LAKE PONTCHARTRAIN, LA. AND VICINITY
CHALMETTE AREA PLAN

DESIGN MEMORANDUM No. 3
GENERAL DESIGN
SUPPLEMENT No. 1
CHALMETTE EXTENSION

LMVED-TD (NOD 21 Oct 68) 1st Ind
SUBJECT: Lake Pontchartrain, Louisiana and Vicinity, Chalmette Area Plan,
General Design Memorandum No. 3, Supplement No. 1, Chalmette
Extension Levee

COMMENTS ON SUPPLEMENT NO. 1, GDM NO. 2, CHALMETTE EXTENSION LEVEE,
LAKE PONTCHARTRAIN, LA., AND VICINITY HURRICANE PROTECTION PROJECT,
CHALMETTE AREA PLAN

72" DRAINAGE STRUCTURE

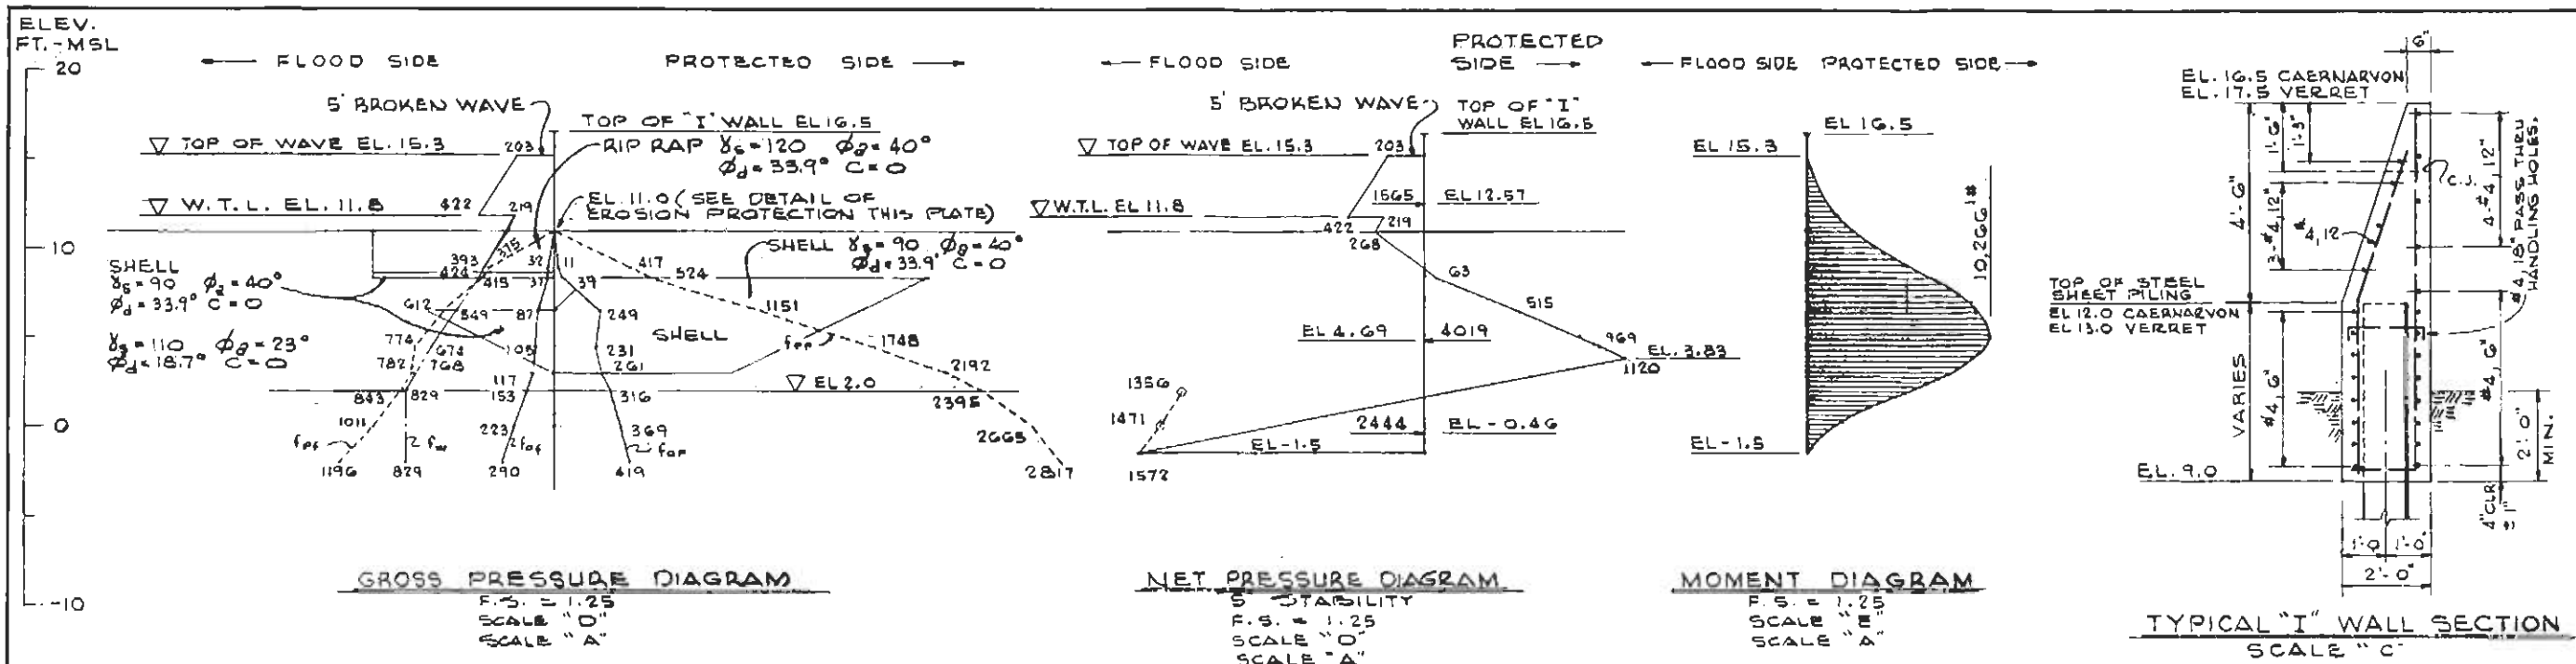
3. Supplement No. 1, Paragraph 40, Drainage Structure. Consideration should be given to changing the 2-72" paved invert corrugated metal pipes to 2-reinforced concrete boxes with collars at all joints. This would afford better corrosion resistance to the salt water.

c. The stability analyses at the 72-inch pipe drainage structure (Plate 61) have been performed assuming the inlet and outlet channels excavated to els -8.0 and -7.0, respectively. The area to be excavated to these elevations is small compared to the area in which the 1 on 4 slope will toe out at natural ground at approximate el +1. Considering the problem to be three dimensional, a conventional stability analysis assuming the inlet and outlet channel bottoms at el -4 would be a satisfactory approach. The 72-inch pipe drainage structure should be of sufficient length to provide a factor of safety of 1.3 for a conventional type stability analysis with the inlet and outlet channel bottoms assumed at el -4.0. The increased shear strengths to be used in the stability analyses should be those due to the first lift previously placed and subsequently excavated for construction of the drainage structure. The stability analyses should be performed for the conditions outlined in para 34, page 21, of the design memorandum.

32. Plates 74, 77, and 81. The size of the steel sheet piling to be used as cutoff beneath the "T" walls and 72-inch pipe drainage structure should be indicated.

- d. At several locations on the plate, the term Ft-Kips is erroneously shown as Ft/kips.
36. Plate 81. Show the steel sheet pile cutoff wall on the plan of the drainage structure.

"I" WALL AT CAERNARVON
SEE PLATE 77 FOR LOCATION

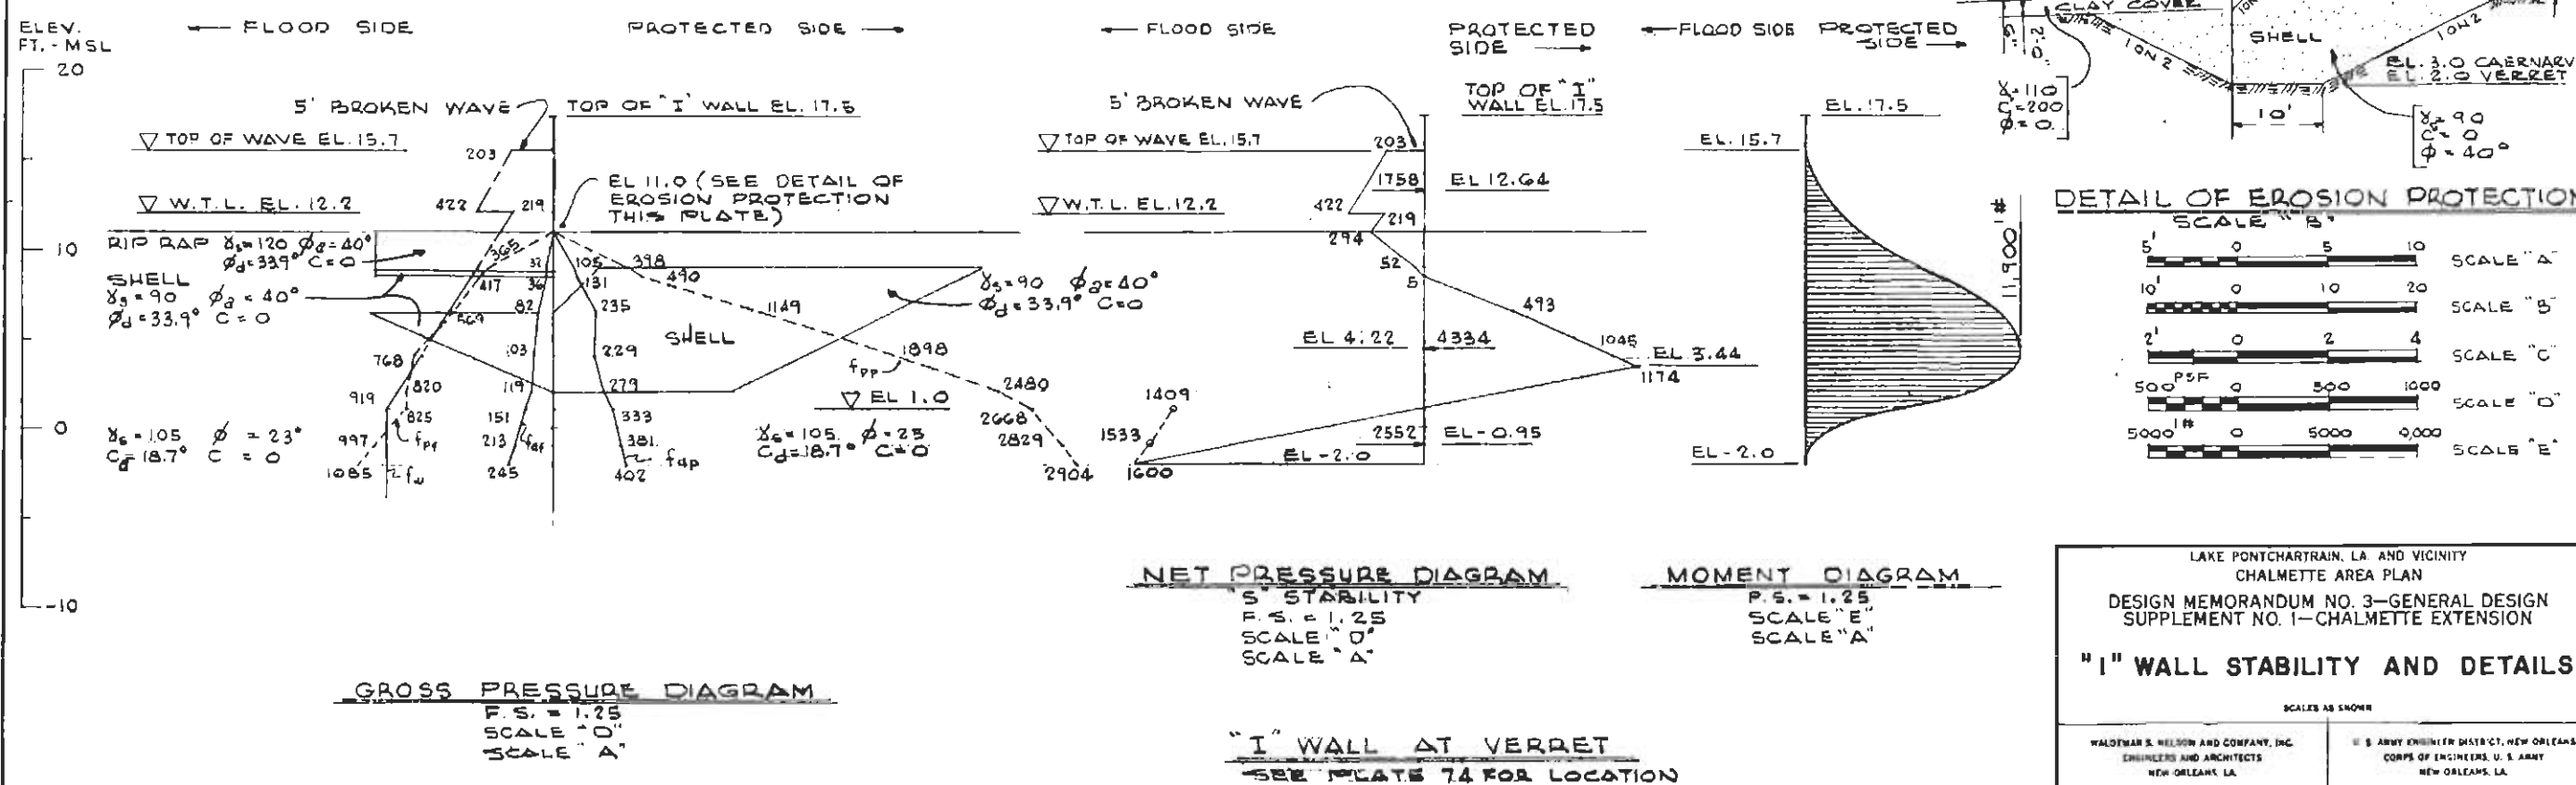
37. Plate 82. The size of the steel sheet piles to be used for the "I"-type walls should be shown on the plate. It is indicated in the estimate on page 37 that MA-22 piles are to be used. Stiffer sheet piles should be used since/the indicated design load applied to the wall, the MA-22 piles will be overstressed and the deflection will be excessive. Suggest that MZ-27 piles be used for the "I"-type walls.
